Sumter City-County Planning Commission

March 24, 2021

MSP-21-09/HCPD-20-08, 3180 Broad St. (City)

Request: Request for Major Site Plan Approval for a +/- 38,000 sq. ft.

Above: Large Site Plan Graphic

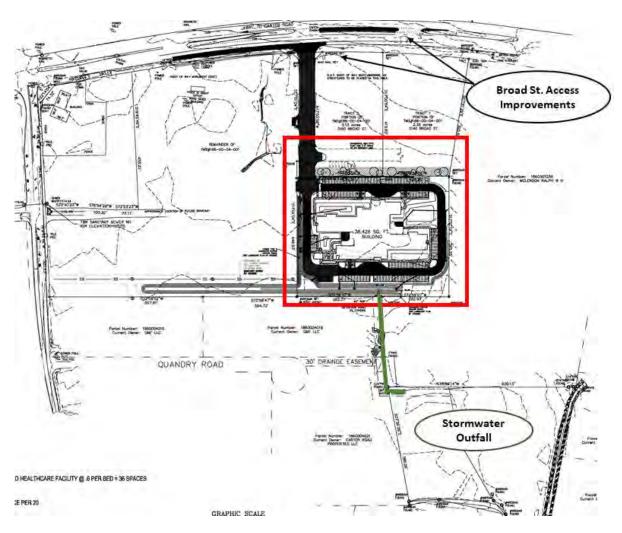
Based upon the criteria found in *Article 8, Exhibit 8-9* of the Ordinance, minimum off-street parking standards for hospital uses require 0.7 spaces per bed and therefore 42 total off-street parking spaces, including 2 handicapped accessible spaces, are required to accommodate the proposed behavioral health hospital. The proposed plan shows 110 total off-street spaces, of which 6 are handicapped accessible.

90-degree angle parking spaces are being proposed. Parking design standards found within Article 8, Section I: Parking Regulations of the Ordinance require 25 ft. aisle widths for 90-

degree angled parking spaces, concrete curb and gutter, concrete or asphalt pavement material, and parking spaces that have at least a 9 ft. x 19 ft. dimension.

The proposed plan shows the following in compliance with applicable standards:

- 183 total parking spaces (9 ft. x 19 ft.)
 - o 165 90-degree angled spaces
 - o 18 dedicated handicapped spaces
- 25 ft. drive aisle widths
- Concrete Curb & gutter
- Asphalt paving surface material

Above: Focused Site Plan Graphic

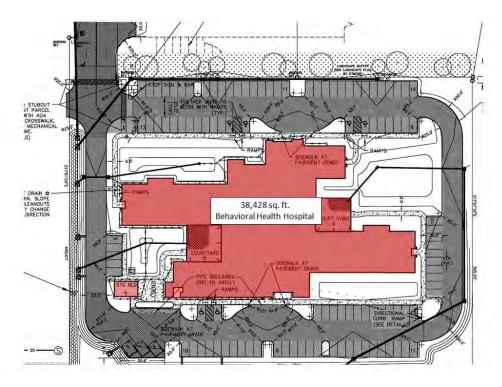
The submitted landscape plan was reviewed against the requirements of *Article 9, Landscaping, Buffer, and Tree Protection Requirements* of the Ordinance. The applicant is proposing the following landscape improvements for this development:

- **Type A Buffer Landscaping (Front, Sides, & Rear)** 3 canopy trees and 20 shrubs per 100 LF are required. The proposed plan provides the required number of plantings along each bufferyard. The proposed canopy tree species will be Willow Oak and Nutall Oak. The proposed understory tree species will be Crepe Myrtle. The proposed shrub species will be Privet and Ruby Loropetalum.
- Interior Parking Lot Landscaping Parking lot islands are required every 15 parking spaces and at the end of each row not abutting a required landscape buffer. Parking lot islands are required to have 1 canopy tree and three shrubs. The proposal landscaping plan meets these specific standards. Bosque Elms and Princeton Ginkgo's are the proposed canopy trees for parking lot islands within the proposed development.

The proposed plan also includes Bald Cypress within the stormwater swale at the rear of the site. Staff finds that these additional canopy trees within the swale meet the intent of the Type B bufferyard requirement since the swale is located at the rear of the development and additional water tolerant tree species are being provided. The proposed plan also includes additional tree plantings and building foundation plantings that are above minimum planting requirements.

Staff recommends approval of the proposed landscaping plan as it exceeds the minimum requirements and meets the overall intent of *Article 9, Landscaping Requirements*. A full plant schedule is included with *Exhibit 3*.

Above: Elevation Rendering – Westside

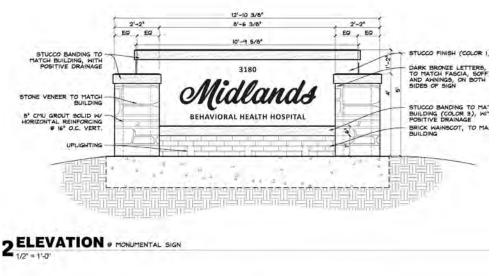
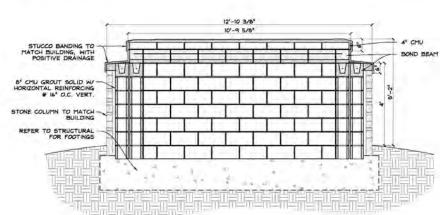
The primary exterior materials, excluding doors and windows, are proposed to be brick, stucco, and stone. The project meets the 80% brick, stucco, or stone masonry threshold. Primary exterior colors will be brown, tan, and gray. Staff finds that the proposed roof pitch of the building is generally compatible with existing commercial development on Broad St.

See the graphic elevation renderings on pg. 10 of this report.

PROJ. NO. SHEET 19026 C3

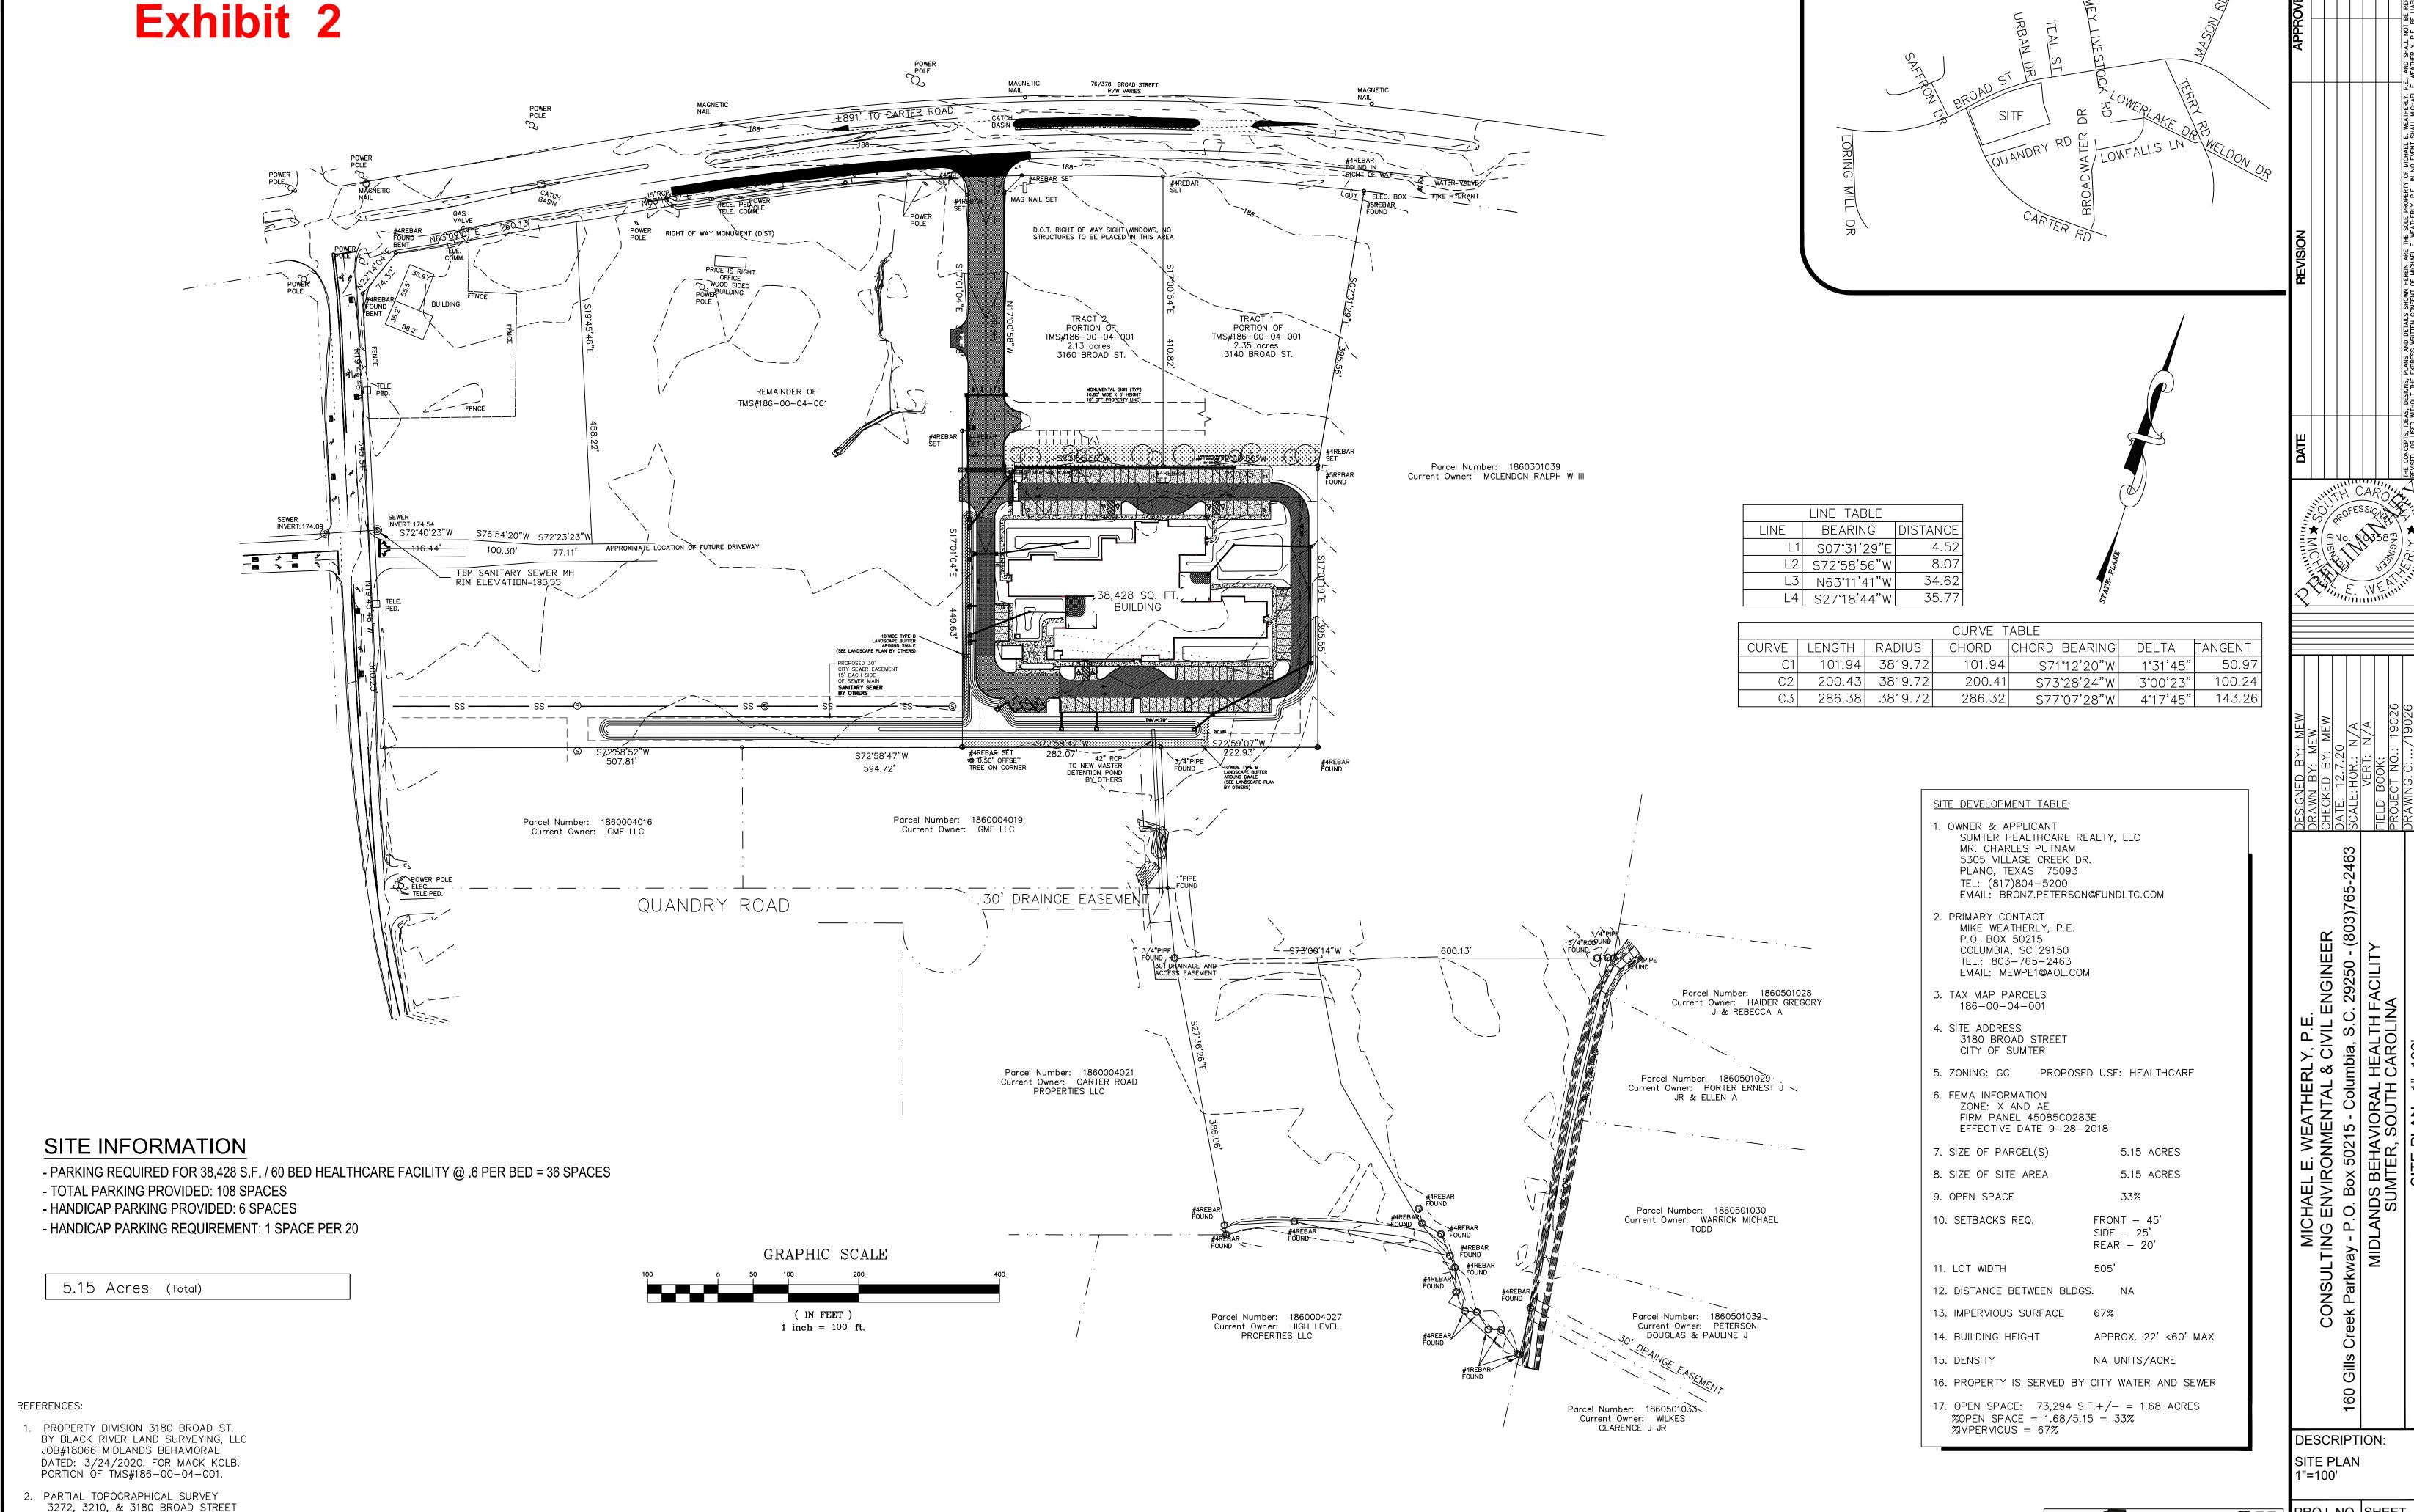
• Revised site plan sheets showing the complete closure of the median opening located in front of Tract 1 and Tract 2 (as shown on Sheet C5) must be submitted. (*Note: the applicant has noted intentions of doing this pending SCDOT acceptance*).

- Revised site plan sheets showing the complete closure of the median opening located in front of Tract 1 and Tract 2 (as shown on Sheet C5).
- 5. Approved city storm water permits shall be obtained and submitted to the Planning Department prior to issuance of land disturbance permits and building permits.
